Natural England's Variation Report to the Secretary of State

Coastal Access Variation Report WBH-VR32
February 2026

Part 2: Proposed variation near to Briarfields Hotel, Titchwell

Part 3: Proposed variation north of St Mary's Church Titchwell

Table 2.3.1: Map WBH 5b Brancaster to Flaxley

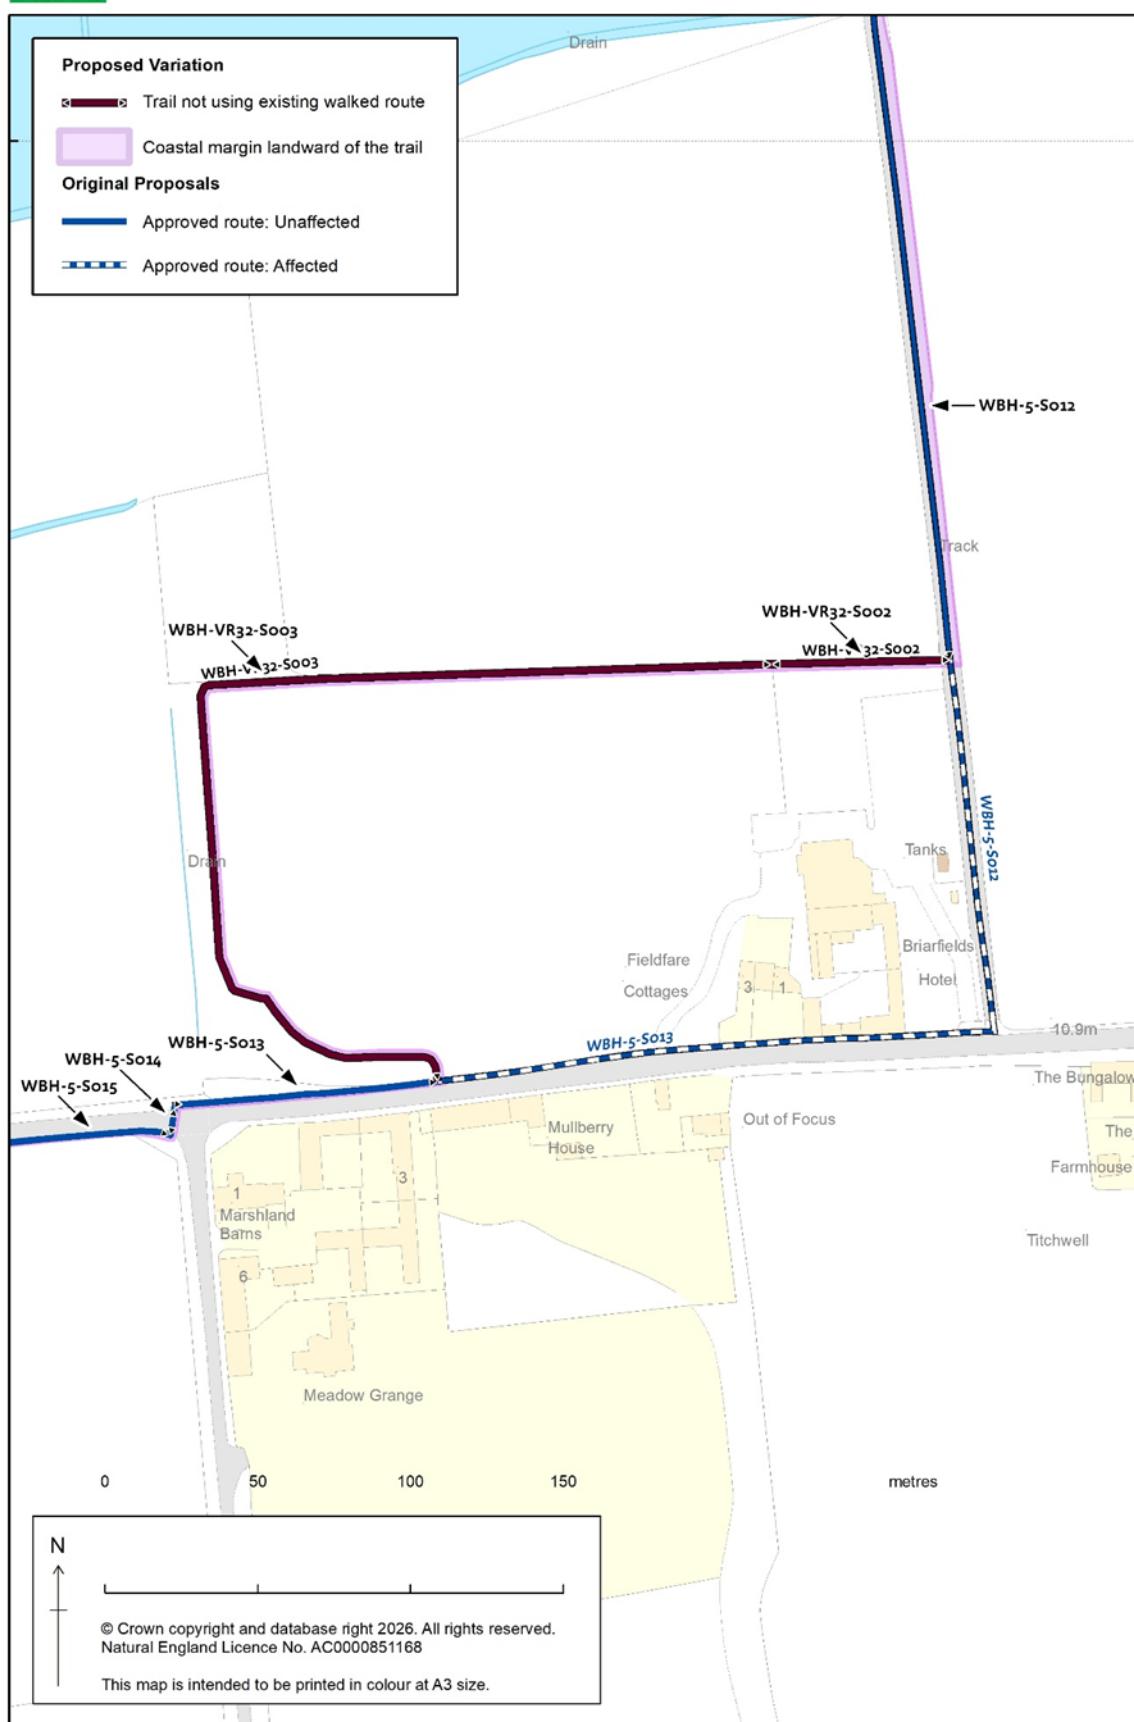
2.1.3 The approved trail on route sections WBH-5-S012 and WBH-5-S013 is along a track adjacent to the Briarfields Hotel and on the pavement on the northern side of Main Road (A149) in the village of Titchwell. The proposed variation would remove some of route sections WBH-5-S012 and WBH-5-S013 and would instead follow the edge of a meadow, on a mown path north and west of the hotel as well as a short section adjacent to a play area. See Variation Location Map VR32d below.

2.1.4 As a consequence of the proposed change, the majority of a grass field will be removed from the coastal margin because it now falls landward of the proposed route.

1	2	3	4	5a	5b	5c	6
Map	New route section number(s)	Current status of route section(s)	Roll-back proposed? (See part 8 of report Overview)	Landward margin contains coastal land type?	Proposal to specify landward boundary of margin	Reason for landward boundary proposal	Explanatory notes
VR32d	WBH-VR32-S002	Not an existing walked route	Yes – normal	No	Fence	Clarity and cohesion	
VR32d	WBH-VR32-S003	Other existing walked route	Yes – normal	No	Landward edge of the trail	Clarity and cohesion
